Access Compliance Report Public Rights-of-Way (Pedestrian Signals)

Main Street: **NEWPORT_BLVD** Cross Street: **NEWPORT_BLVD** Location: **S**

ADA ID: **SGRK211012171804** Signal Type: **One Push Button-Non APS** Overall Compliance: **No** Severity Scores: **BTN 1: 35** **BTN 2: N/A** **No BTN: N/A**

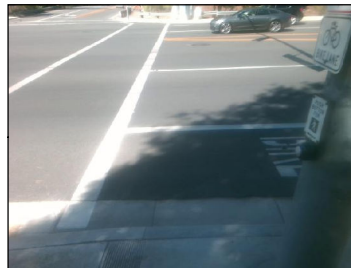
Yes	B 1 Diameter (in)	2	N/A	B 2 Diameter (in)	N/A
N/A	B 1 Crossing Direction	N	N/A	B 2 Crossing Direction	N/A
No	B 1 DistanceTo XWalk (in)	74	N/A	B 2 DistanceTo XWalk (in)	N/A
Yes	B 1 DistanceTo Curb (in)	32	N/A	B 2 DistanceTo Curb (in)	N/A
	Parcel Identification Number	503-381-15			
	Google Street View Link				
	http://www.google.com/maps/@?api=1&map_action=pano&viewpoint=33.77444722,-117.78714075

Possible Solutions: Replace Signal Push Button With APS Button. Remove & Relocate Sign.
